Delaware Basin in Eddy County

Changes to APD FOR Federal Wells Batch Drill

HH SO 10 15 FED 002	6H	30-015-44367
HH SO 10 15 FED 002	5H	30-015-44371
HH SO 10 15 FED 002	4H	30-015-44353
HH SO 10 15 FED 002	3H	30-015-44351
HH SO 10 15 FED 002	2H	30-015-44354
HH SO 10 15 FED 002	1H	30-015-44352

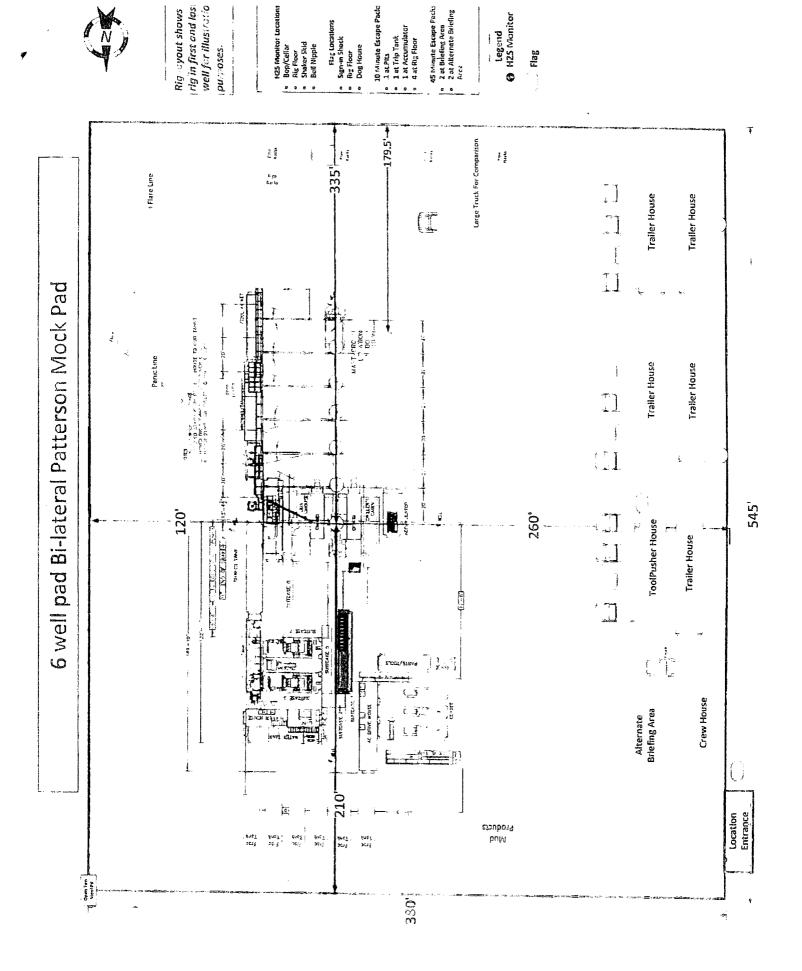
- 1. Drill 17-1/2" surface hole with fresh water to planned casing set depth with 10' rat hole.
- 2. Run casing as stated by approved APD, land out wellhead, and cement.
- 3. Dress out 13-5/8" 5M SH-2 wellhead and install/secure with temporary abandonment cap and a pressure gauge will be installed. Reference image below Part U 399984.
- 4. Skid to next well according to below "Drill Order".
